ADDENDUM NO. 3

DATE: July 23, 2018
FROM: City of Grand Junction Purchasing Division
TO: All Offerors
RE: Las Colonias Business Park Phase 2 IFB-4547-18-DH

Las Colonias Business Park Phase 2
Lake Ventilation System Plan

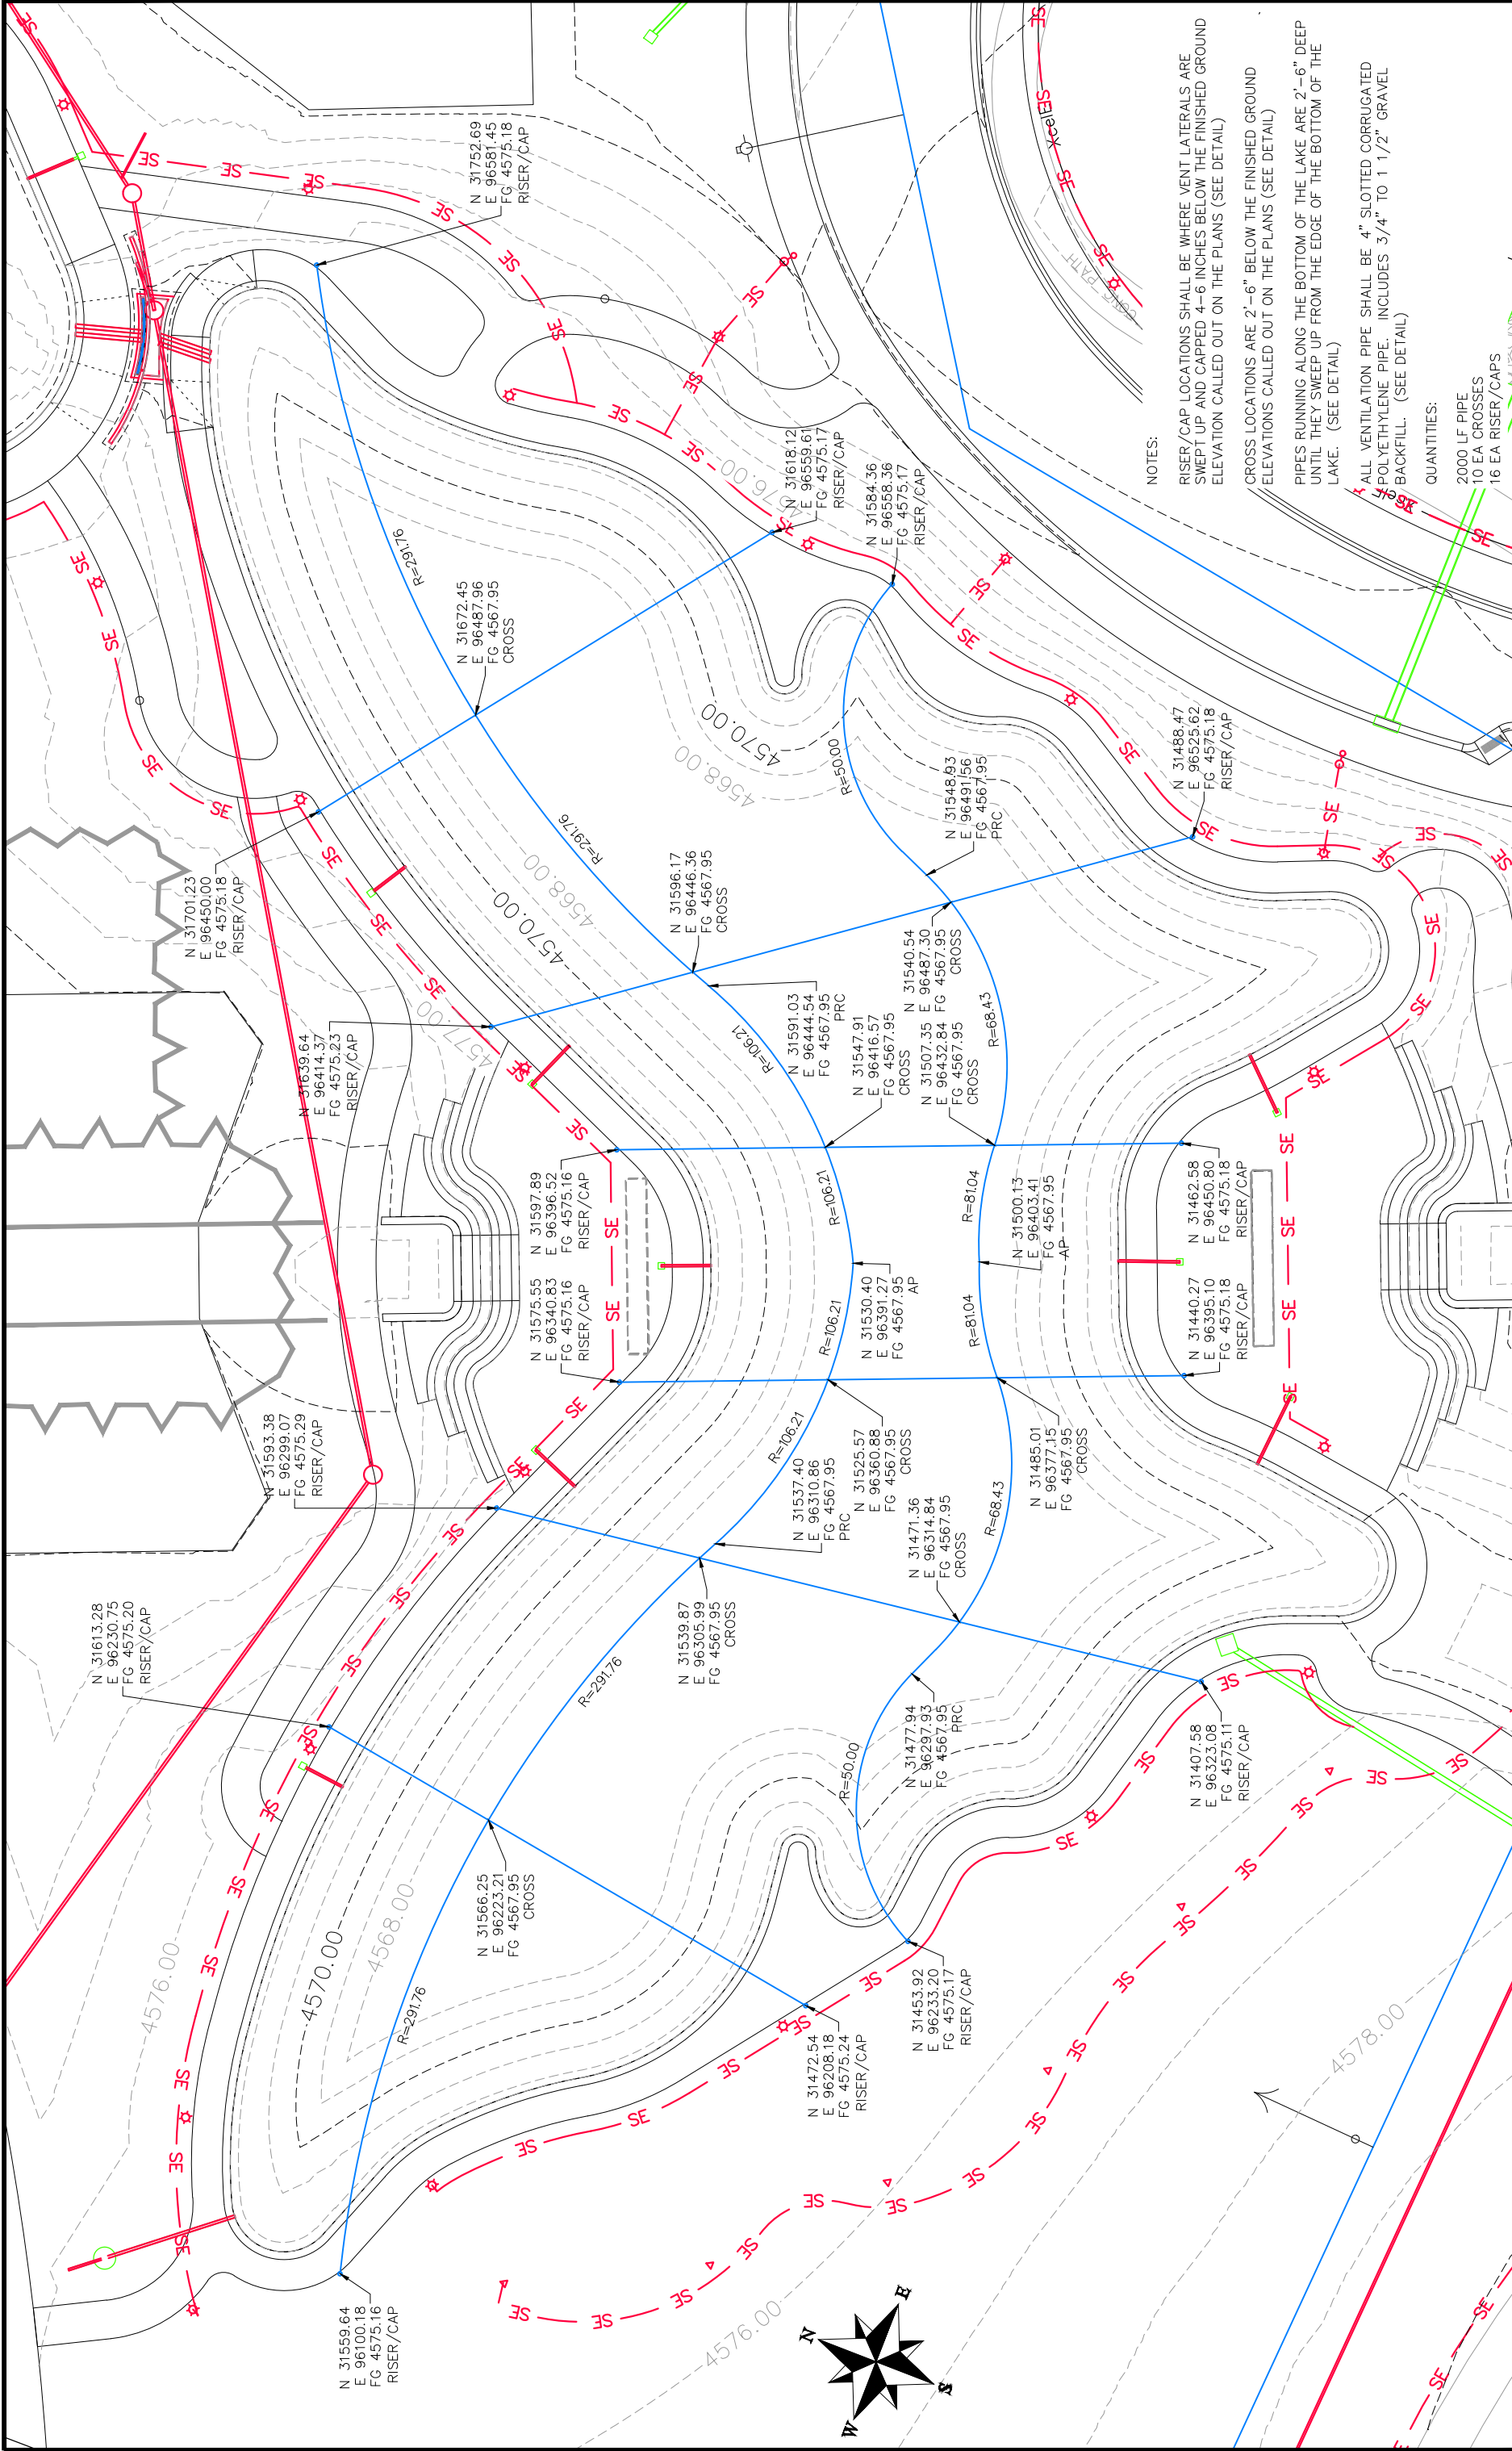
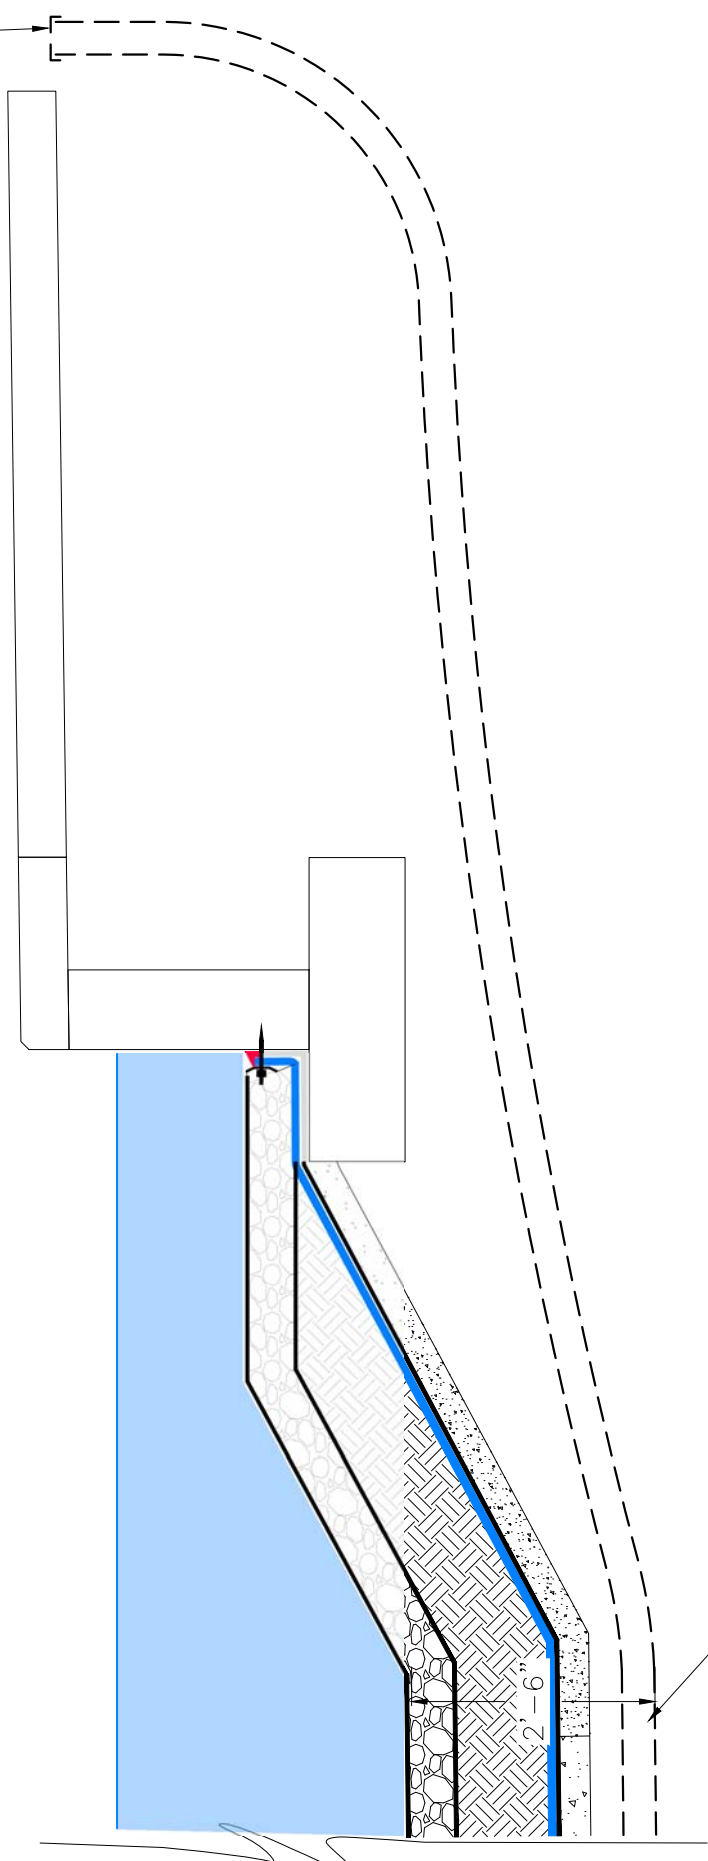
1. **Pond Liner Ventilation System** – See plan sheet and detail attached to Addendum No. 3. This work shall include approximately 2,000 lineal feet of 4” slotted corrugated polyethylene pipe, 10 crosses, 16 risers with caps and any other necessary appertencies to complete ventilation system.

RISER/CAP LOCATIONS SHALL BE WHERE VENT LATERALS ARE SWEEPED UP AND CAPPED 4-6 INCHES BELOW THE FINISHED GROUND ELEVATION CALLED OUT ON THE PLANS (SEE DETAIL)

CROSS LOCATIONS ARE 2'-6" BELOW THE FINISHED GROUND ELEVATIONS CALLED OUT ON THE PLANS (SEE DETAIL)

PIPES RUNNING ALONG THE BOTTOM OF THE LAKE ARE 2'-6" DEEP UNTIL THEY SWEEP UP FROM THE EDGE OF THE BOTTOM OF THE LAKE. (SEE DETAIL)

ALL VENTILATION PIPE SHALL BE 4" SLOTTED CORRUGATED POLYETHYLENE PIPE. INCLUDES 3/4" TO 1 1/2" GRAVEL BACKFILL. (SEE DETAIL)

LAS COLONIAS BUSINESS PARK PHASE 2
COMPOSITE UTILITY PLAN

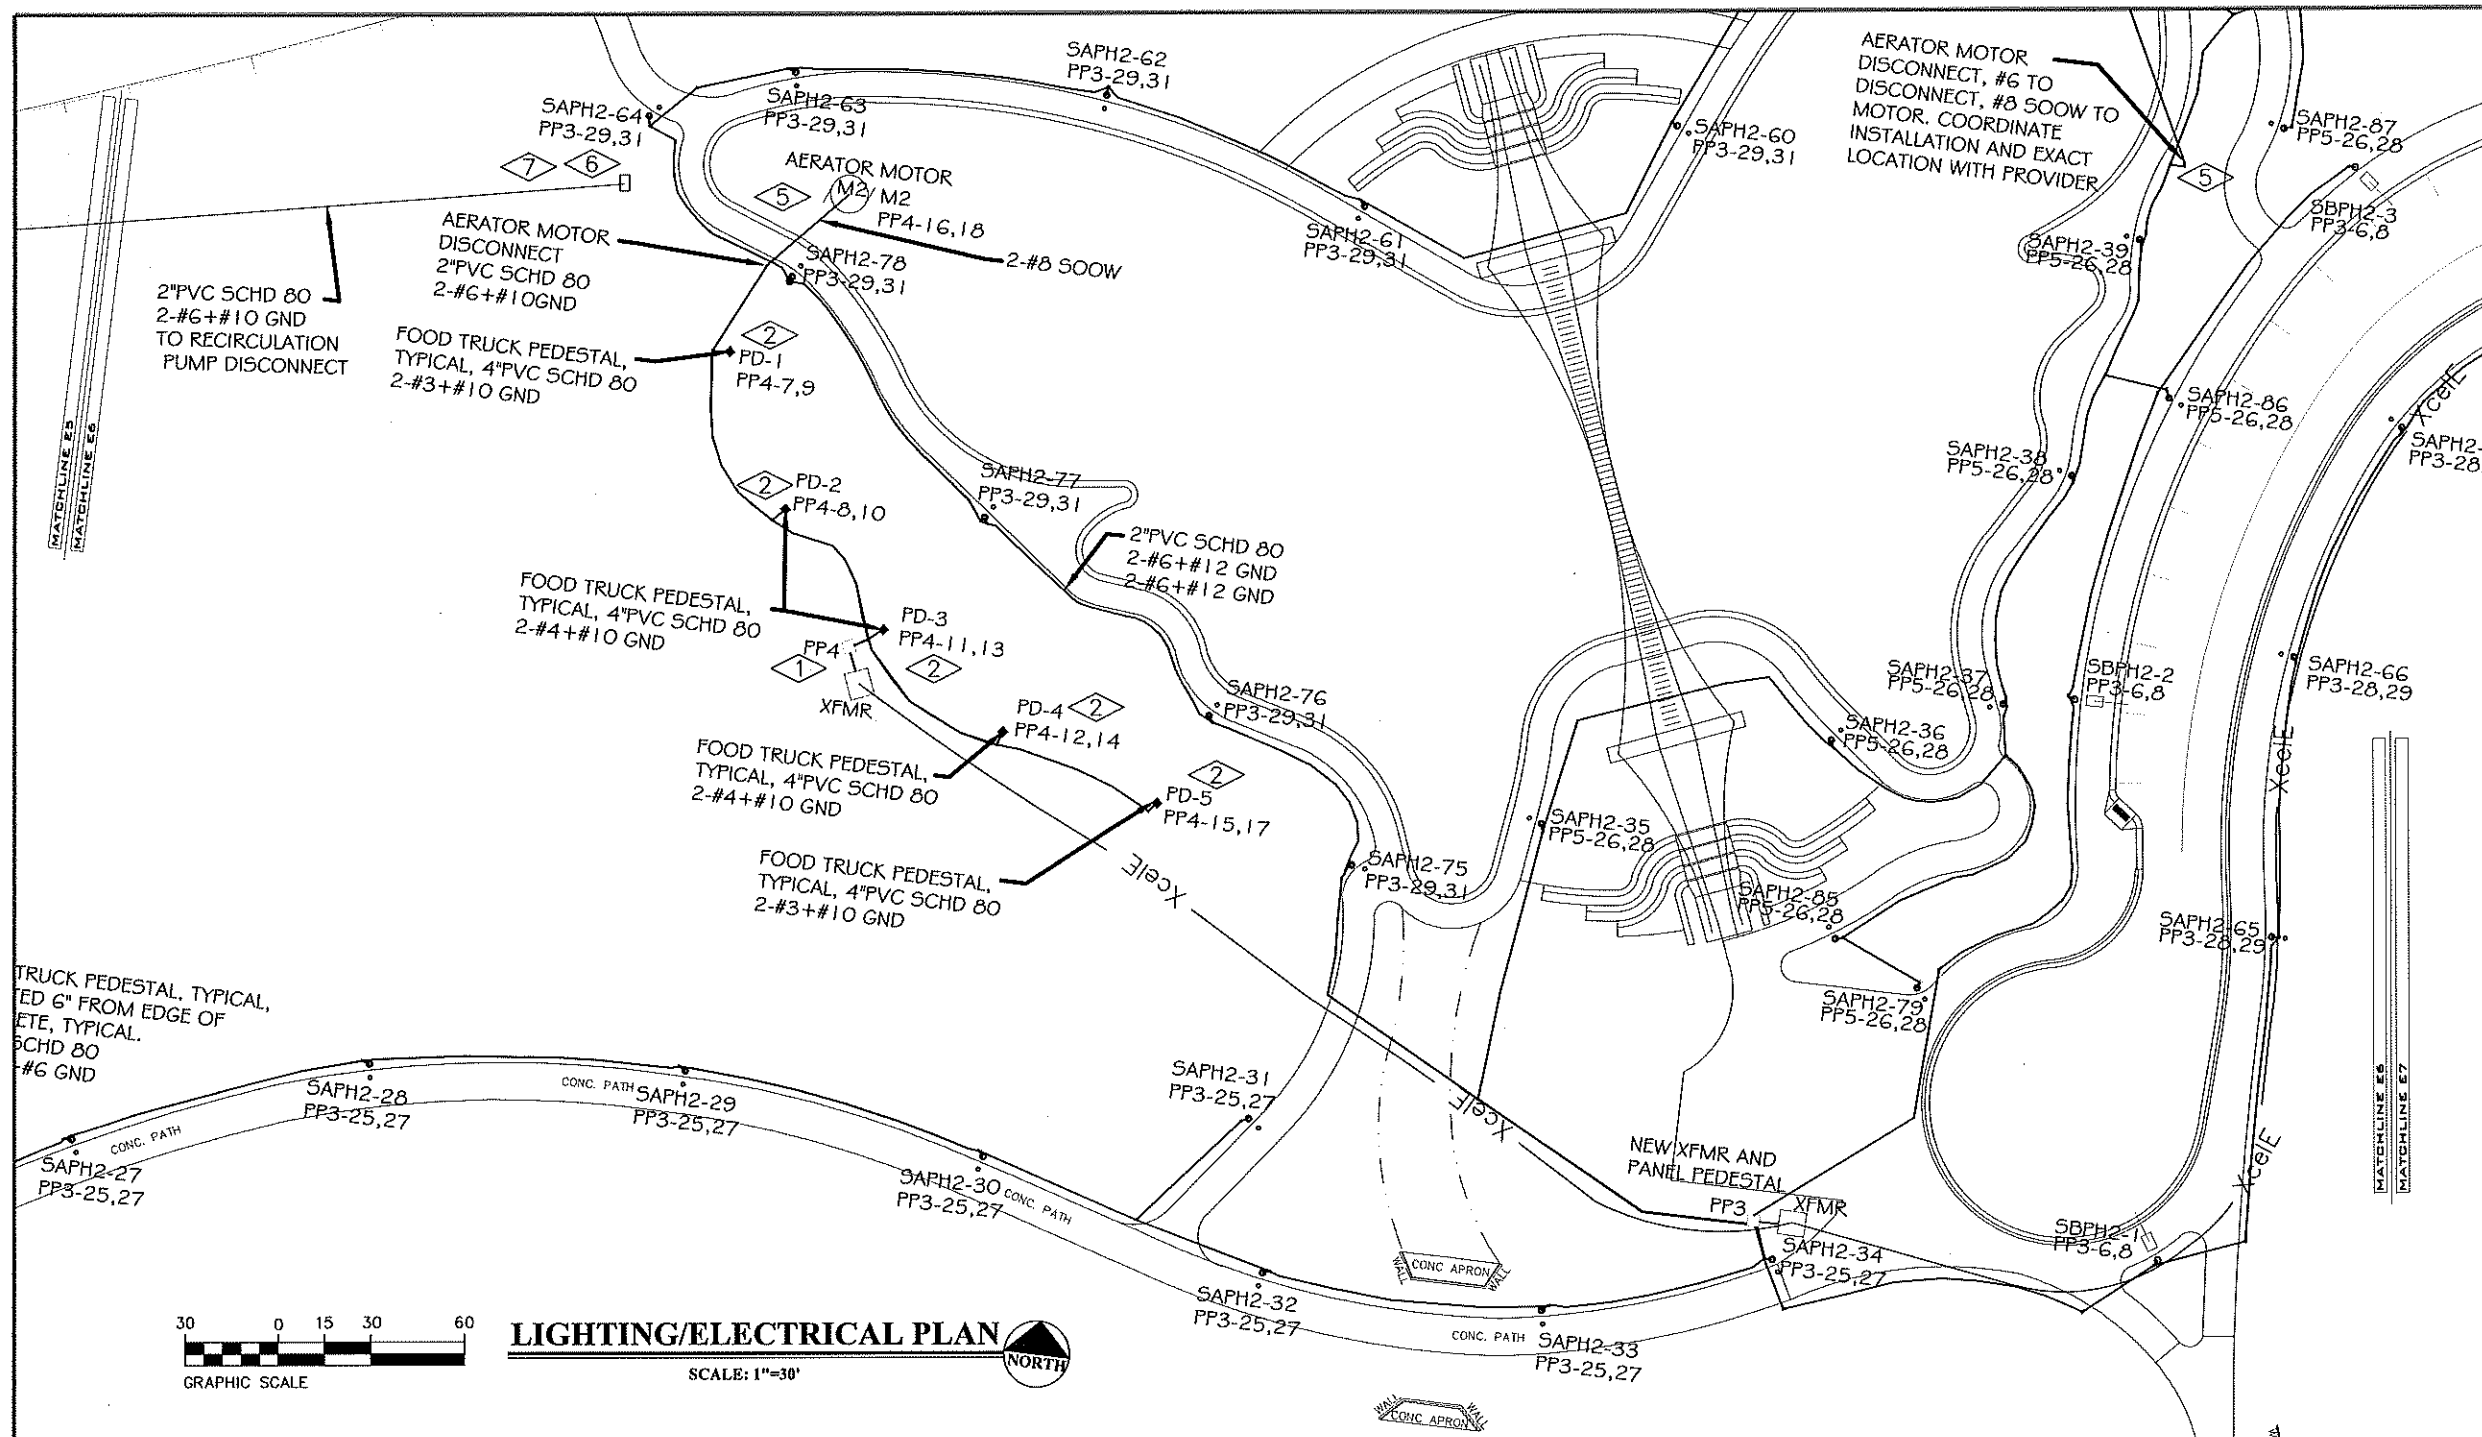
7. Electrical – See revised plan sheets attached.

DESCRIPTION	DATE	DRAWN BY	DATE
REVISION Δ ADDENDUM 3, LEVEL CONTROL POWER	7-24-18	AJM	7-12-18
REVISION Δ		AJM	7-12-18
REVISION Δ		AJM	7-12-18
REVISION Δ		JT	7-12-18

- ① PROVIDE 2" PVC SCHEDULED 80 CONDUIT WITH PULL STRING FOR FUTURE FROM PANEL PP5, TERMINATE IN JBOX.
- ② PROVIDE 2-#10 + #12 GND FROM NEW 20 AMP BREAKER IN PANEL PP5 TO POND LEVEL TRANSMITTER, COORDINATE EXACT LOCATION AND WIRING WITH PROVIDER PRIOR TO ROUGH-IN.

LAS COLONIAS BUSINESS PARK PHASE 2
COMPOSITE UTILITY PLAN

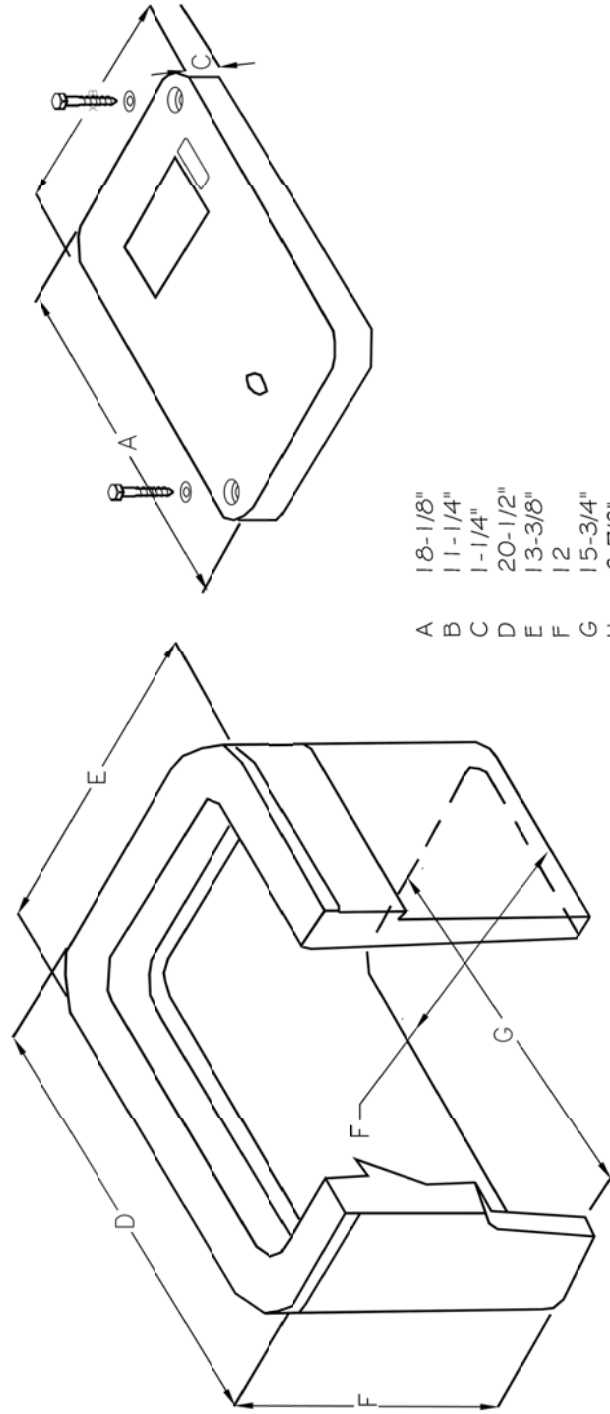
REVISION	DESCRIPTION	DATE	DRAWN BY	DATE
REVISION Δ	ADDENDUM 3, CLARIFIED NEW NEMA 3R PANEL	7-24-18	AJM	7-12-18
REVISION Δ			AJM	7-12-18
REVISION Δ			AJM	7-12-18
REVISION Δ			JT	7-12-18

- ① NEW 200 AMP 3 PHASE 208/120VOLT 4W PEDESTAL PANEL PP4 AND TRANSFORMER, COORDINATE INSTALLATION WITH XCEL PRIOR TO ROUGH-IN.
PEDESTAL TO BE MOUNTED IN SOIL, COORDINATE MOUNTING WITH PROVIDER PRIOR TO ROUGH-IN.
- ③ PROVIDE POWER TO FOOD TRUCK PEDESTALS FROM EXISTING PANEL PP4.
- ④ NEW 200 AMP 3 PHASE 208/120 VOLT 4W PEDESTAL PANEL PP3 AND TRANSFORMER, COORDINATE INSTALLATION WITH XCEL PRIOR TO ROUGH-IN.
- ⑤ COORDINATE INSTALLATION OF AERATOR MOTOR WITH PROVIDER PRIOR TO ROUGH-IN. PROVIDE 20A 1-PHASE 208 VOLTS NEMA 3R DISCONNECT INSTALLED PER CDOT STANDARD PLAN NO. M-613-1 SHEET 4 OF 4.

- ⑥ PROVIDE 3-#6 THWN TO NEW DISCONNECT FOR PUMP. FROM DISCONNECT PROVIDE 3-#6 THWN TO MOTOR. DISCONNECT AND CONTROLLER FOR MOTOR WILL BE ACTUATED WITH SIGNAL FROM FLOAT VALVE AT EAST LOCATION OF GOGGLE PONDS. FIELD VERIFY EXACT LOCATION WITH PROVIDER PRIOR TO INSTALLATION, REFERENCE SHEET 25 OF CITY PHASE 2 OUTLET WORKS PLAN AND PROFILE.
- ⑦ DISCONNECT AND CONTROLLER FOR MOTOR TO BE INSTALLED IN A NEMA 3R PANEL. COORDINATE EXACT SIZE OF PANEL WITH CONTROLS PROVIDER PRIOR TO ORDERING.
